SUBJECT: Project #304033  
F-9500(13), M/V  
LeCONTE Galley  
and Finishing Mod.

On November 28, 1986, AMHS headquarters personnel (\*) met and reviewed the concept design and recommendations prepared by the Glostn Associates for the subject project. Pertinent comments attached.

SUBJECT: M/V LeCONTE Galley & Finishings Modifications

## SECTION II

Drawn By	Date	Checked By	Date	Approved By	Date
CARONK	11/18/80	WLM	1/19/81	WLM	1/19/81
Scale	Drawing No.		Rev.		
1/8"=1'-0"	8677-A		Sheet 1 of 4

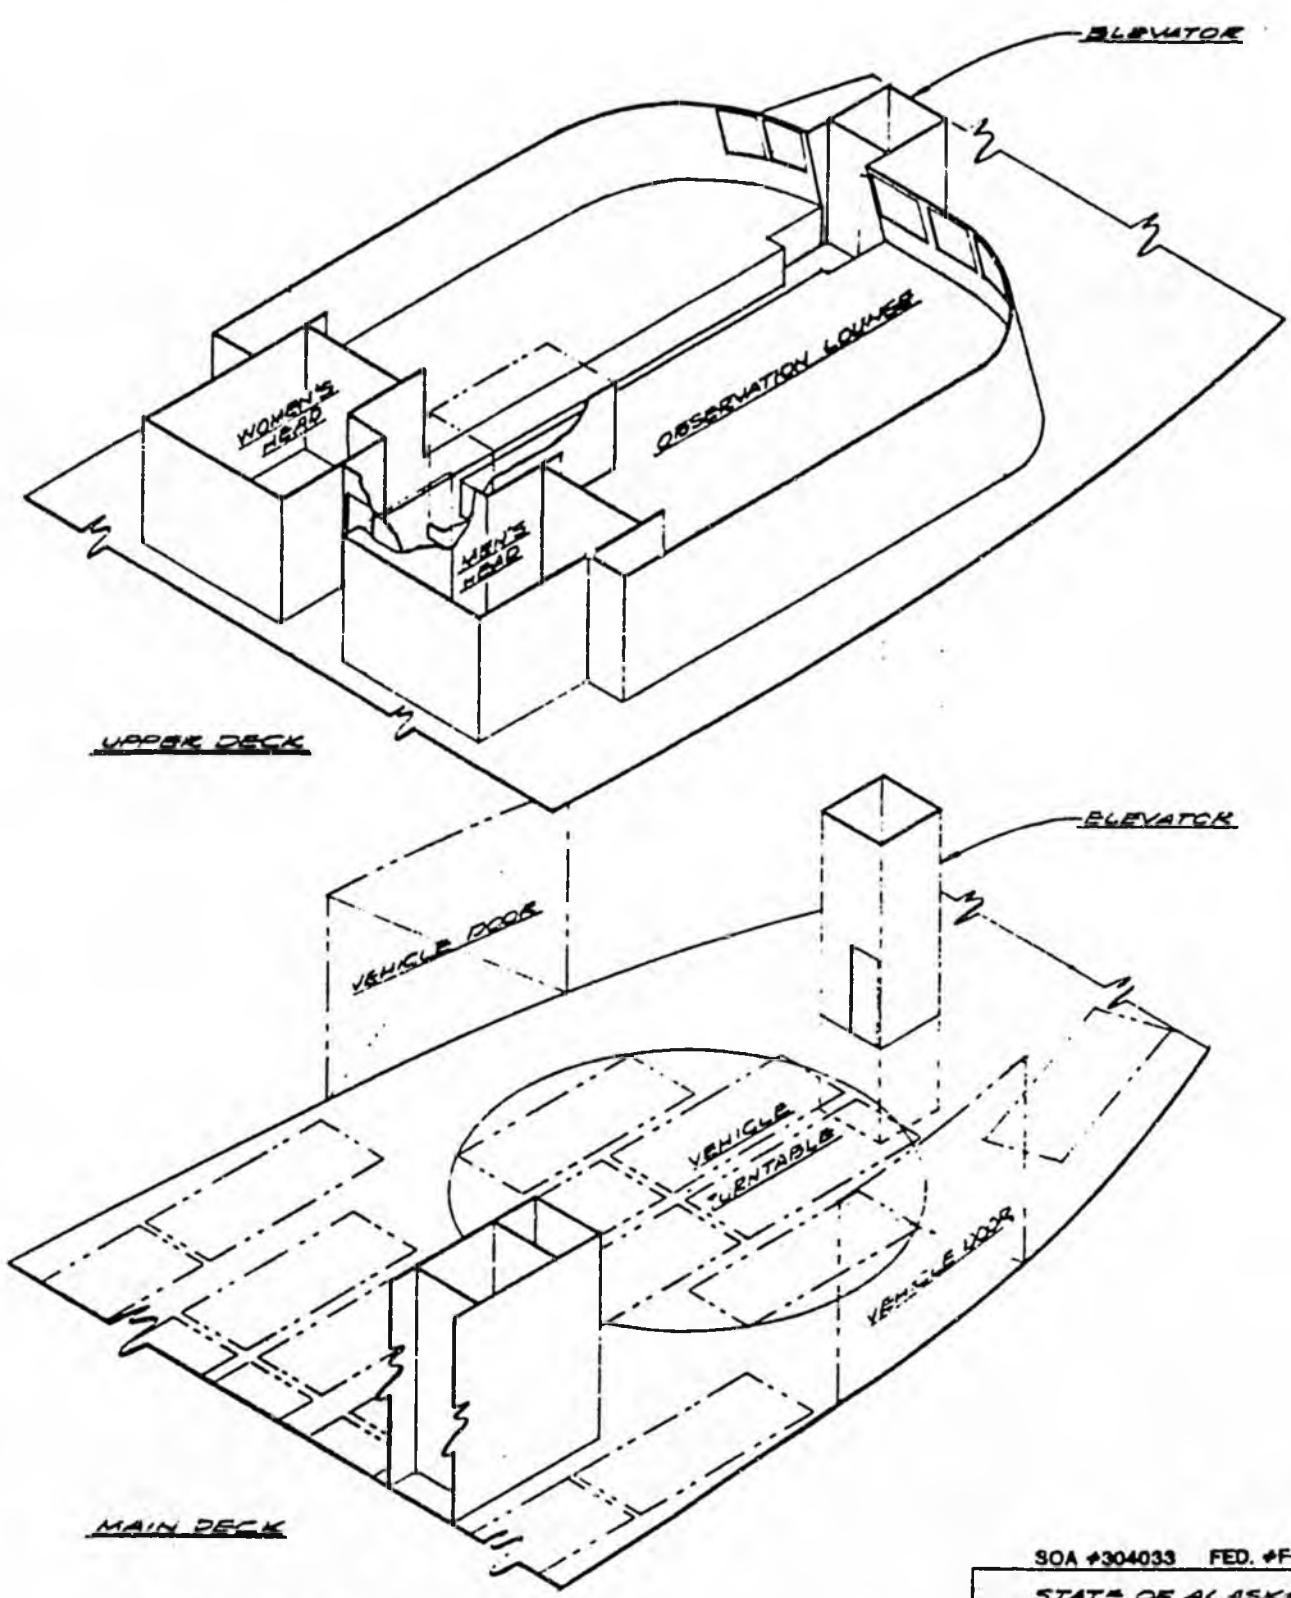
A steel hoistway with external dimensions of 75" x 75" is built down into the void aft of the bow thruster compartment, and up above the upper deck in front of the house. A recessed walkway is built into the observation lounge at the level of the foyer, and steps and handrails rearranged. Steps are added as shown on Drawing 8677-A, Sheet 1.

- o About six seats in the forward observation lounge are lost, but two are added next to the elevator.
- o There is excellent access at the main deck.
- o The hoistway at the main deck will interfere with the 2 foot overhang of trailers on the turntable.

Drawn by	Date	Checked by	Date	Approved by	Date
CAC/CH	1/20/80	WJH	1/20/80	WJH	1/20/80
Scale	Drawing No.		Rev.		
1/8" = 1'-0"	8677-A		Sheet 2 of 4

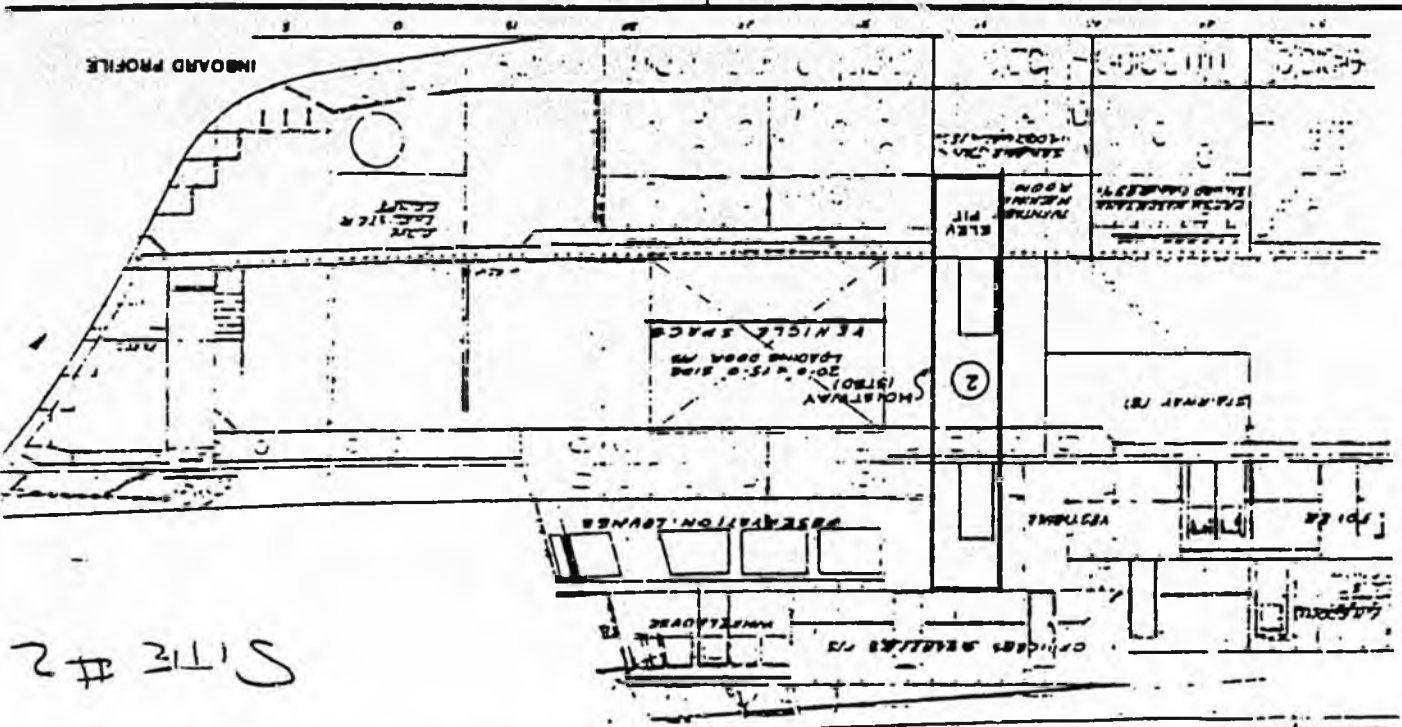
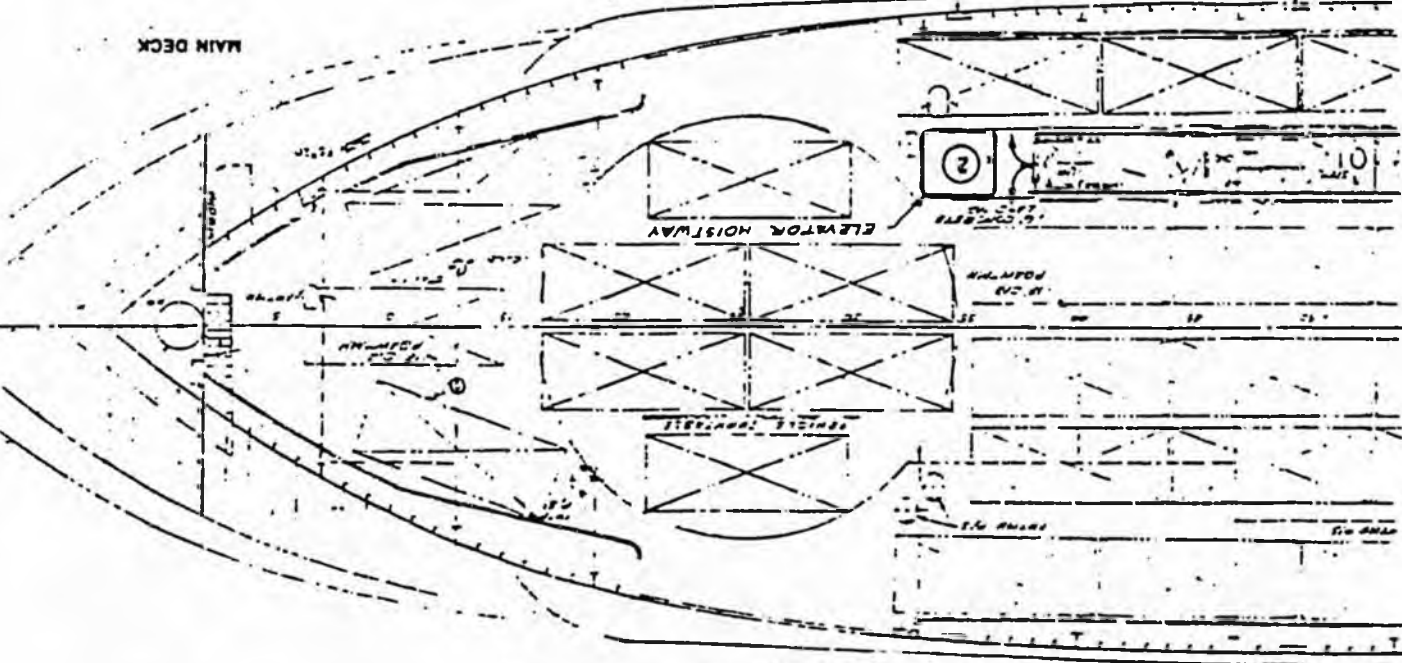
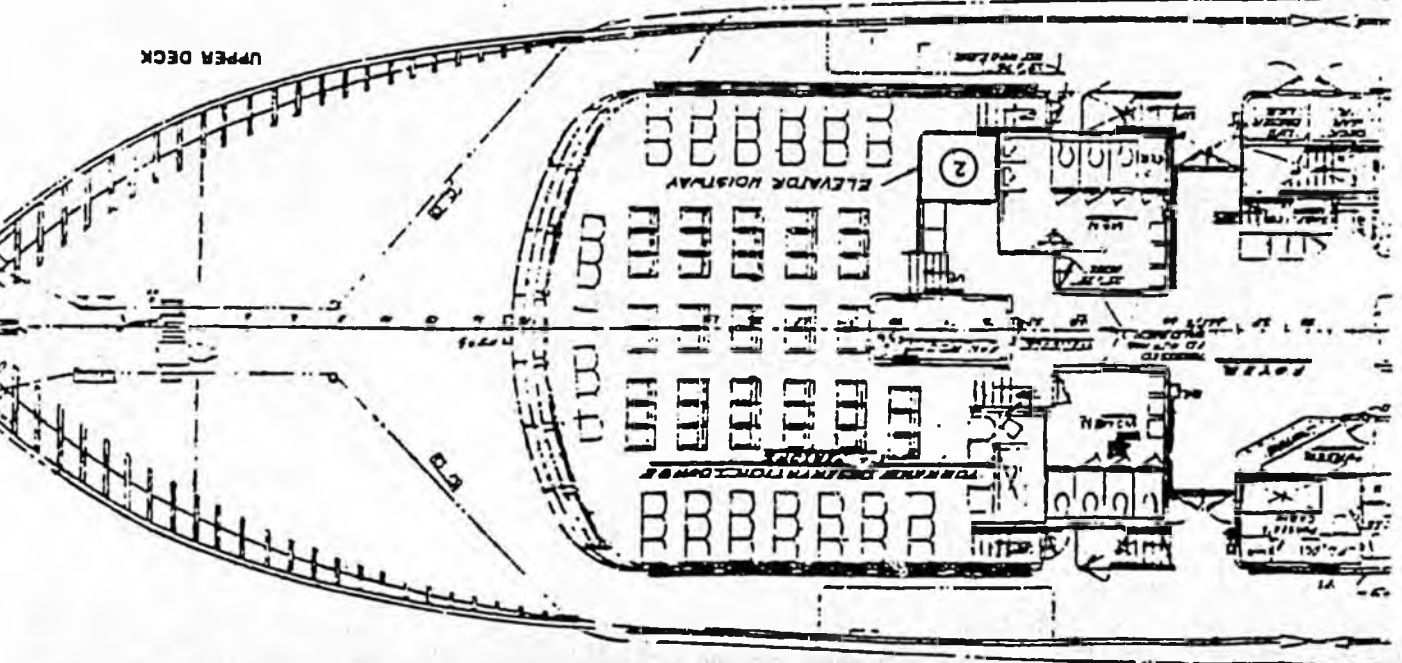
AMHS personnel agreed and accepted the Glostn Associates recommended "enclosed hoistway" concept and elevator installation site #2 (approximate frames 33 to 36, starboard side forward of the machinery casing) as the optimum design.

During the period 1/9/87 through 1/23/87, a hoistway obstruction was placed on the main (car) deck in way of the proposed elevator site (#2 - Glosten Concept, dated 11/20/86).

I visited the vessel on each arrival in Auke Bay (1/9, 1/11, 1/16, 1/18 and 1/23) specifically to witness loading operations. In each instance, several attempts were required to situate vehicles (31' to 40' excluding the tractor unit). It must be pointed out that the main deck in all cases was devoid of other vehicles, which afforded ample room to maneuver these units. However, this luxury normally would be precluded during peak traffic months by through traffic.

Discussions with the Chief Mate indicate that occasions arise that require using the turntable to load "booked" traffic in excess of twenty-eight feet (28'). The turntable will not function unless the applied weight is evenly distributed which causes a one to two foot (1' to 2') overhang of the vehicle being loaded with the turntable (turntable diameter is 32'). The elevator hoistway location is within eight inches (8") of the turntable perimeter. It appears that the turntable, depending on traffic, will be unusable.

The installed hoistway will eliminate the turning radius currently available and required to clear the transfer bridge when loading standard size vehicles in the "tunnel". The "tunnel" is presently loaded aft to forward by backing vehicles in. The hoistway location also reduces the effective "tunnel" width from eight to six feet (8' to 6') at the forward end. A standard vehicle is approximately six feet (6') in width excluding any

While it appears that the vessel can accommodate units larger than twenty-eight feet (28') in length, the actual capability cannot be documented under the conditions encountered. Furthermore, accessibility to and from the "tunnel" will be severely reduced.

I would suggest that this portion of the subject project be deferred until such time as the elevator installation can be accommodated in such a way as to not interfere with the vessel's present capabilities.

ENCLOSURE 1  
 TO GLOSTON  
 LETTER TO MSC,  
 15 NOV 86

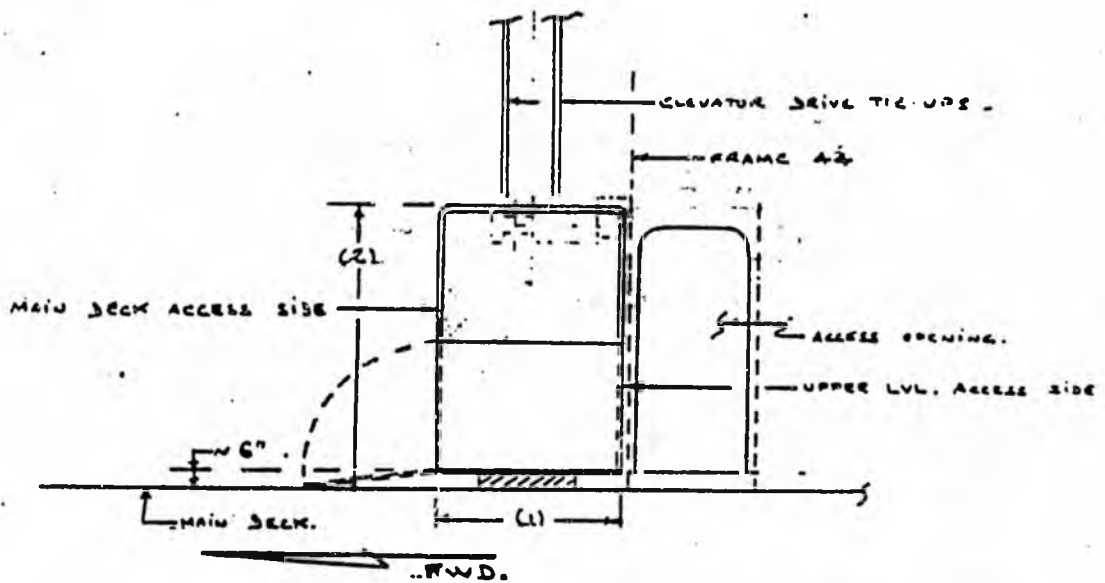
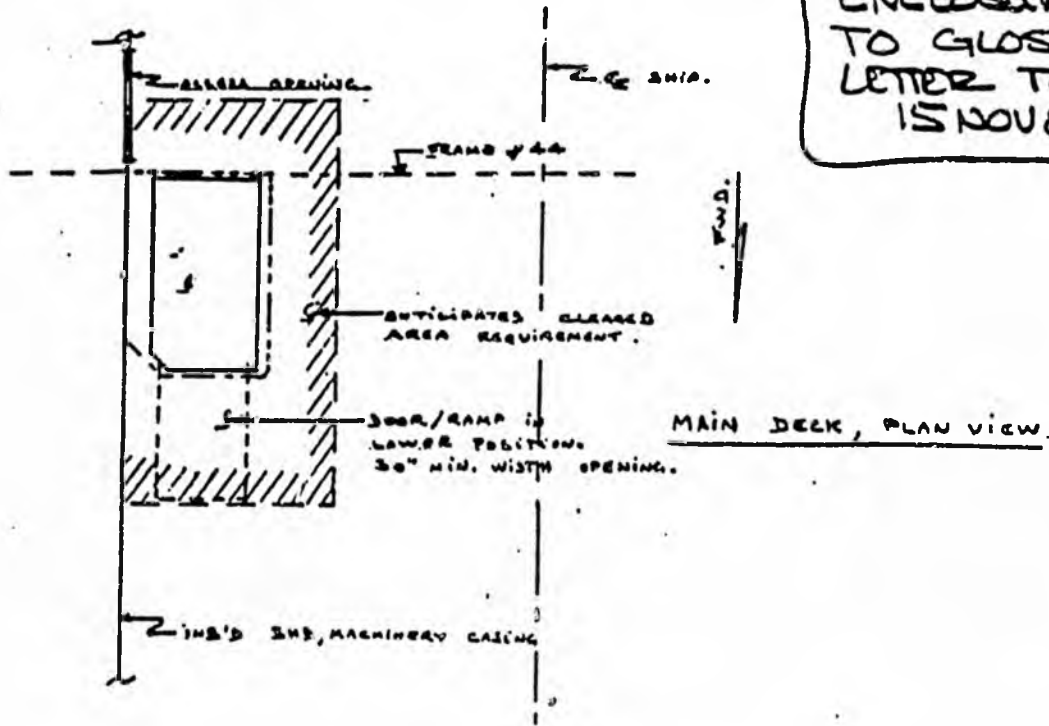
You will notice in the enclosed sketches that the upper deck is penetrated by the upper end of the hoistway, and this box structure would be a fire boundary as required for the overhead of the car deck. One wall of this box structure would have fire doors for access in and out of the elevator car. We note however that when the car is not at the upper deck level, while being used dockside, the box structure would be open on the bottom.

We compare the box structure to the penetration of a stairwell above the main deck. We further note that while there is no door at the bottom of the box structure, as there is at the bottom of a stairway, there also is no enclosed hoistway. This elevator would not be used during fire and would not need to be considered a "safe haven", like a stairwell.
